AKH Knitting & Dyeing Ltd.

92, Phulbaria, Tetuljhora, Savar-1347, Dhaka.
(23.80997 N, 90.248941 E)

Observations Made

AKH Knitting & Dyeing - Building 9

Roof Bracing in Dining Area of Building 7

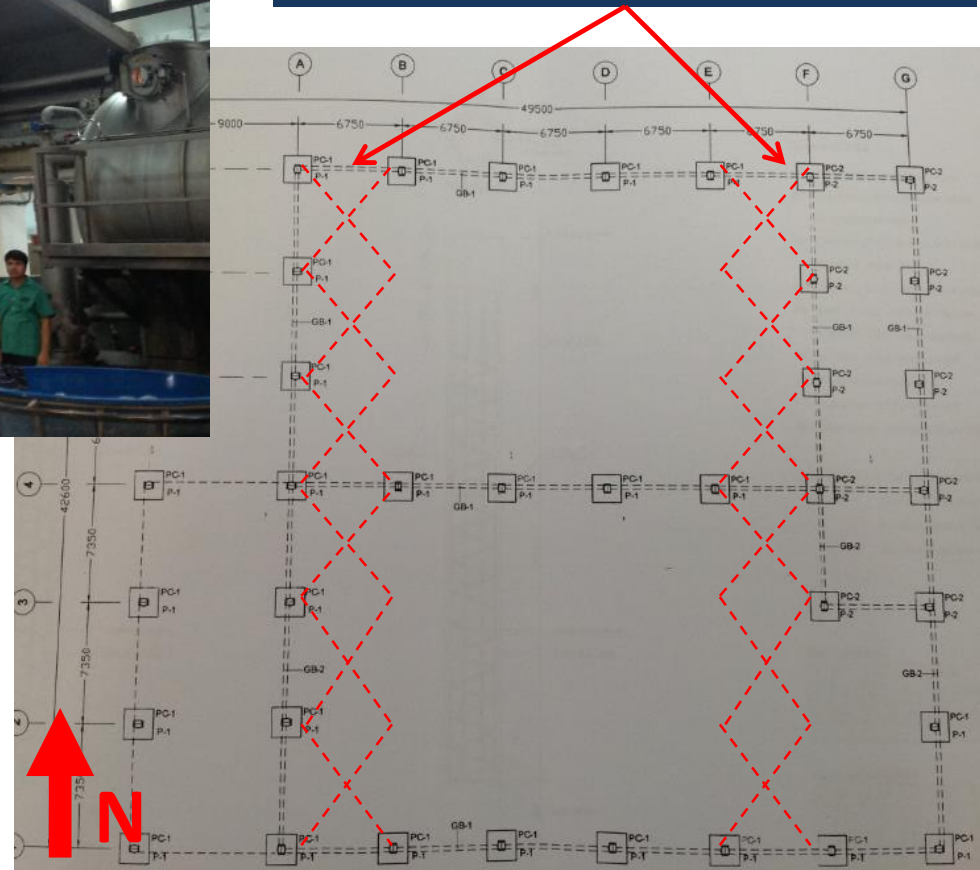
Bracing elements are slack and should be tightened to ensure they are functioning correctly.

Item No.	Observation	Recommended Action Plan	Recommended Timeline
1	Roof Bracing in Dining Area of Offices (Building 7)	Re-tighten all horizontal bracing elements in the Roof Structure for the Dining Area of Building 7.	6-weeks
2	Roof Bracing in Dining Area of Offices (Building 7)	Continue to Implement Load Plan.	6-months
3	Roof Bracing in Dining Area of Offices (Building 7)	If bracing elements slacken again, re-tighten accordingly.	6-months
4	Dyeing Shed (Building 3) stability system	Review the stability calculations for the Dyeing Shed to ensure it is a robust structure in both directions.	6-weeks
5	Dyeing Shed (Building 3) stability system	Continue implementing load plan.	6-months

Undocumented horizontal extension on the ground floor

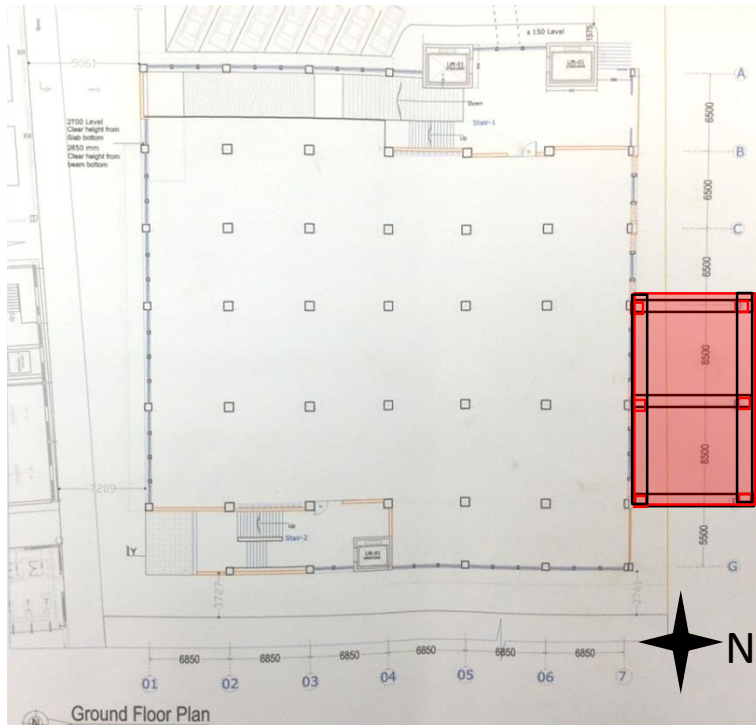
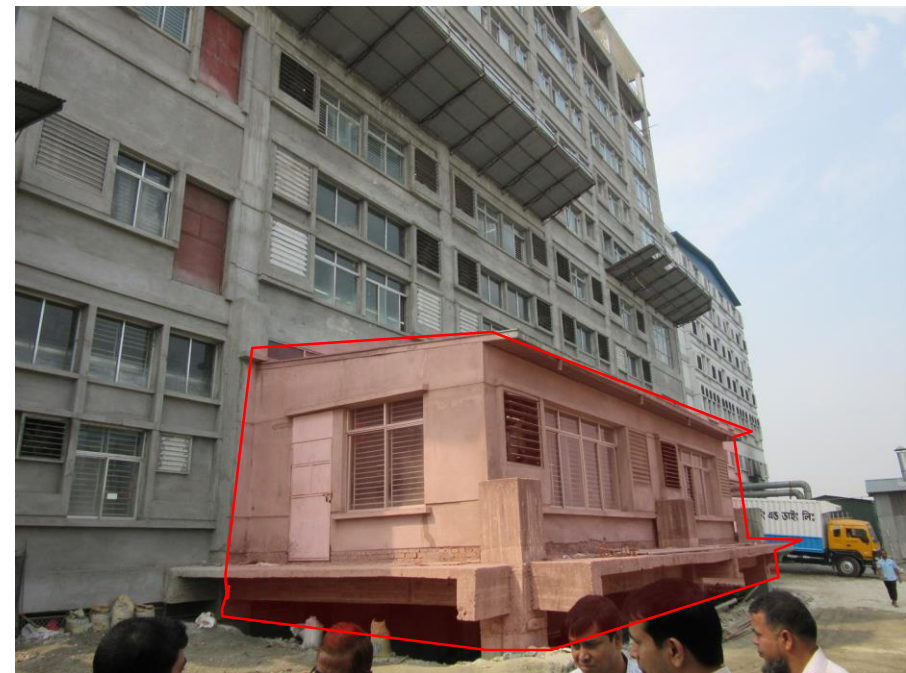
- Horizontal single storey extension to building on the ground floor
- No additional loads added to primary structure, as expansion joint was observed between the columns
- Building documentation to be updated to reflect this additional structure

Item No.	Observation	Recommended Action Plan	Recommended Timeline
1	Undocumented ground floor extension	Building drawings to be updated to match as-built structure.	6-months
2	Apparently non-engineered steel roof structures	Building Engineer to perform design check for lightweight steel roofs, including lateral stability and uplift in high winds.	6-months
3	Apparently non-engineered steel roof structures	Main Building structure to be assessed for additional loading from roof extensions where applicable (e.g. South Extension)	6-months

Apparently non-engineered steel roof structures

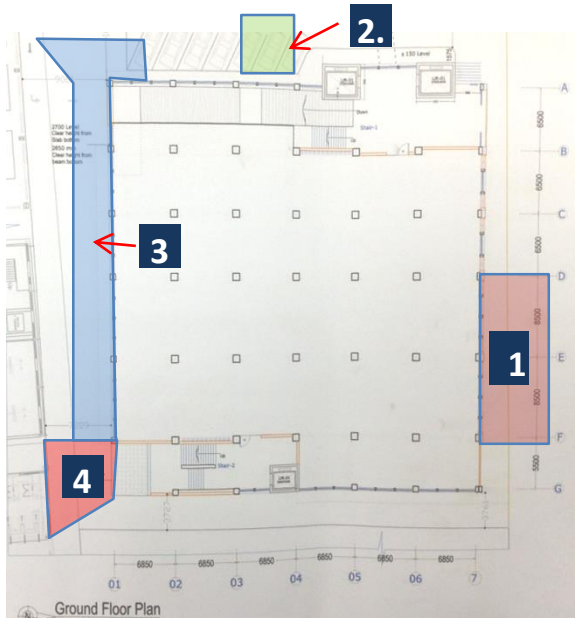
- Non-engineered roof structure without bracing system.
- Roof structures subject to uplift in high winds.
- Factory Engineer to assess roof structure for vertical (including uplift) and lateral loads.

(Non-structural Observation)
Limited edge protection on the 7th floor

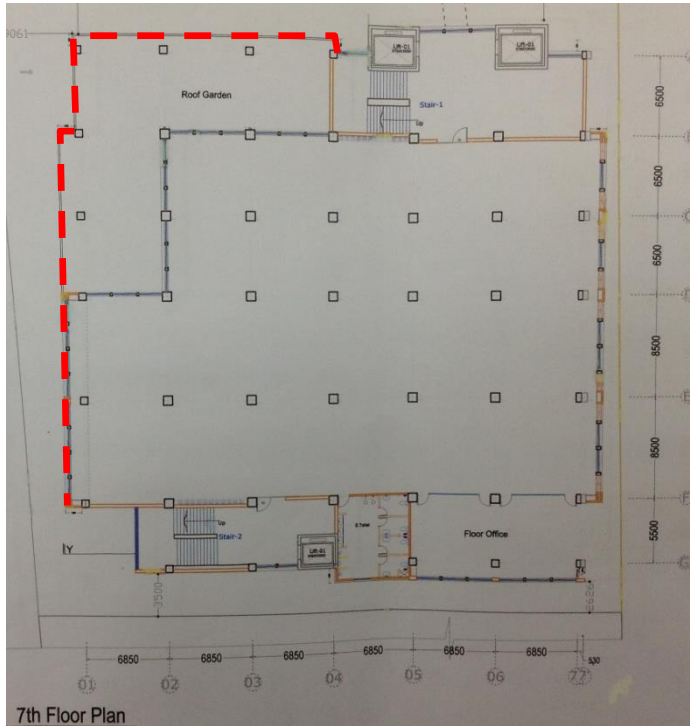
- Low parapet around future roof garden providing insufficient fall protection.
